NAVAJO NATION ENVIRONMENTAL PROTECTION AGENCY
Water Quality/NNPDES Program
P.O. Box 1999
Shiprock, New Mexico 87420
Phone: (505) 368-1037
FAX: (505) 368-1416

January 16, 2004

RE: Navajo EPA Water Quality Program Concerns at the Shiprock Uranium Mill Tailings Site

Figure 1. Contaminant concentrations in well 0835 and surface water site 0934 between 1998 and 2003.

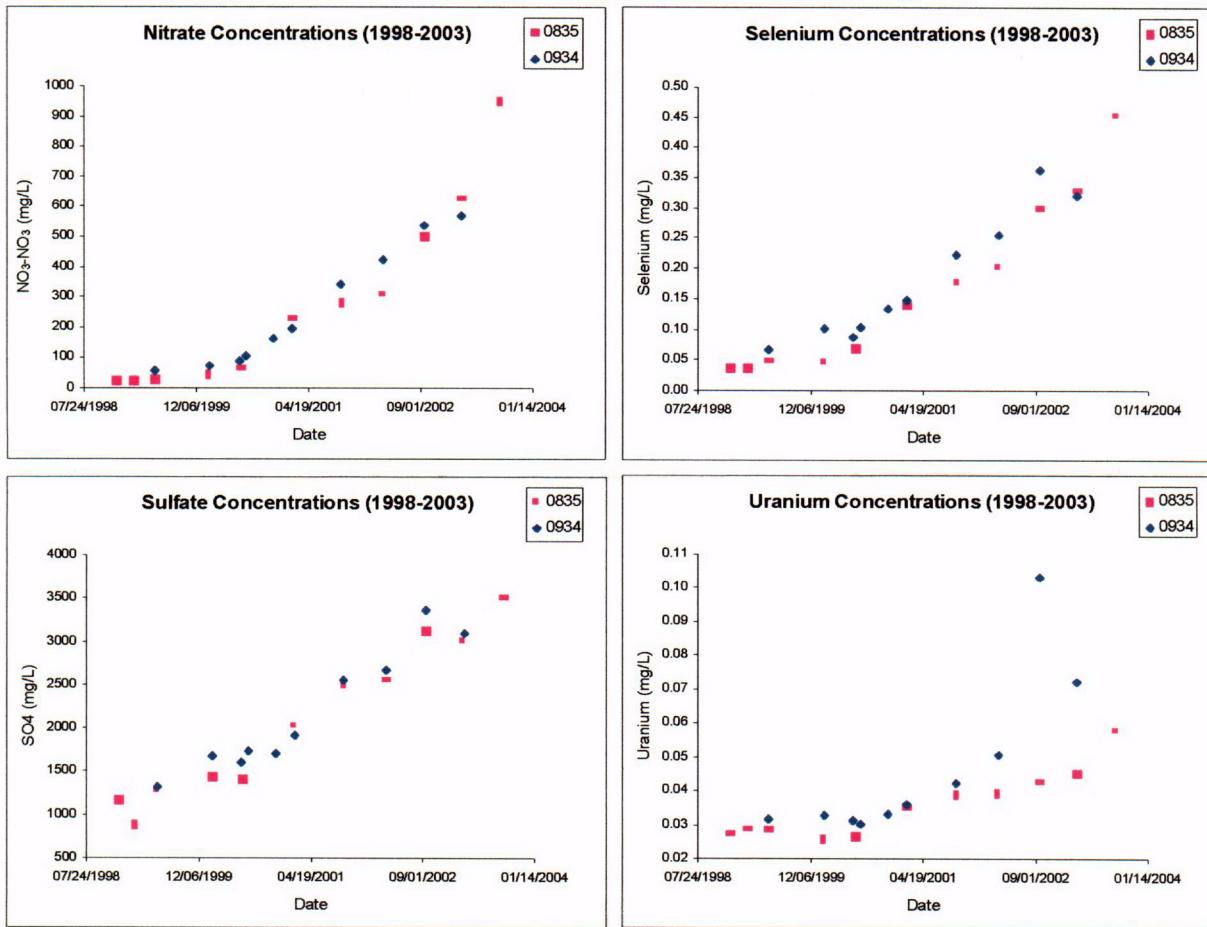
The past six years of data indicate that the terrace plume is migrating to the northwest along the area between Shiprock High and 2nd Wash. This is most apparent in wells 0835, 0838, and 0847/1079 and surface location 0934. Well 0835 and surface location 0934 are located near and in 2nd Wash, respectively. This area has seen concentrations of nitrate, selenium, sulfate, and uranium steadily increase since 1998 (Figure 1). The concentrations for each of these parameters now exceed the MCLs, benchmarks, and cleanup goals.

Figure 2. Contaminant concentrations in wells 0838 and 0847/1079 between 1998 and 2003.

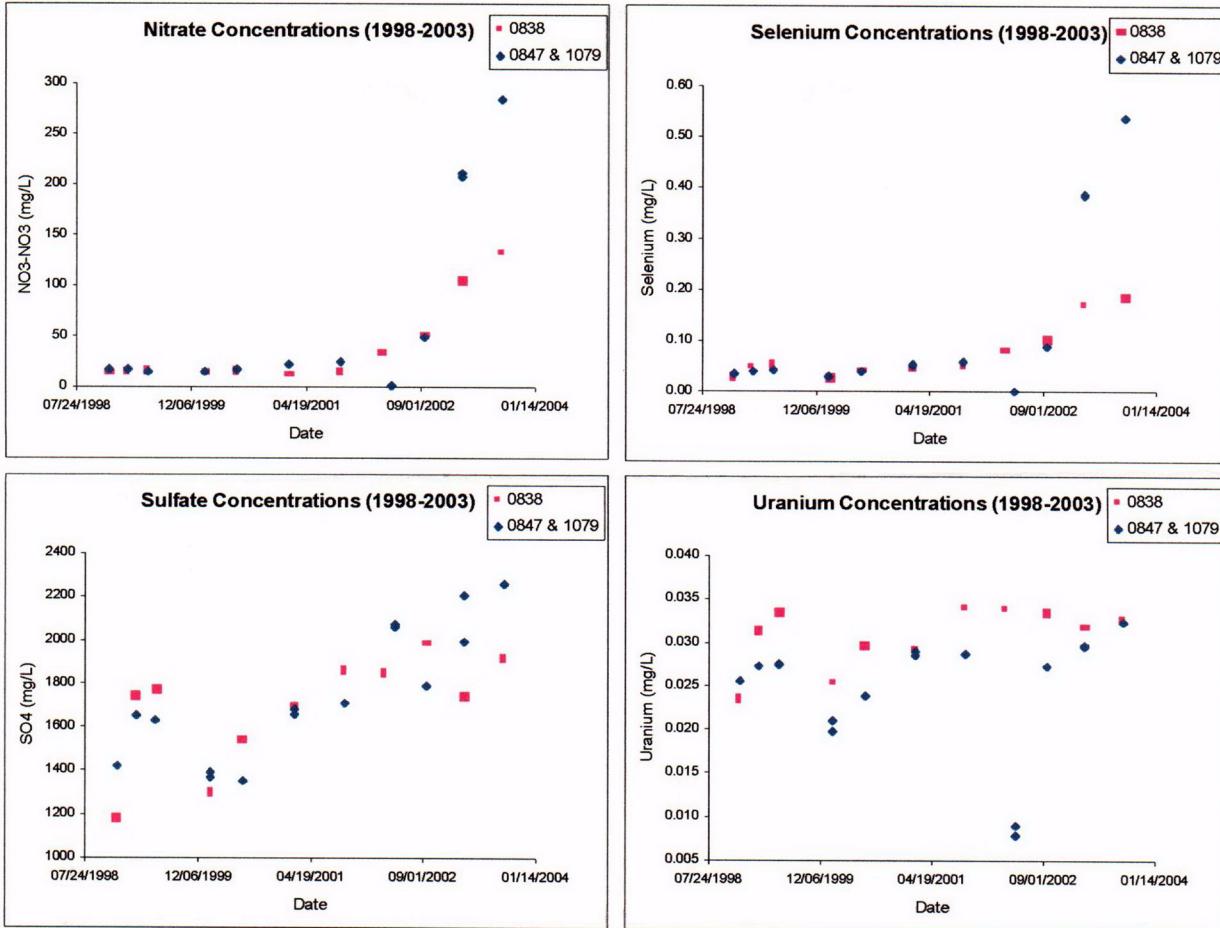
Although not as dramatically, wells 0838 and 0847/1079 near the high school have also been increasing over time (Figure 2). In these wells, sulfate concentrations have varied over the past six years, but the general trend is upward. Concentrations for sulfate are currently near the benchmark of 2000 mg/L. Nitrate and selenium were relatively stable until about three years ago, but they have both sharply increased since 2001. This change appears to coincide with the cessation of farming in the area where the new Dine College campus is being built. Both nitrate and selenium are now significantly greater than the MCLs. Uranium concentrations have slightly increased over the past six years, but they have not exceeded the MCL in either well to date.
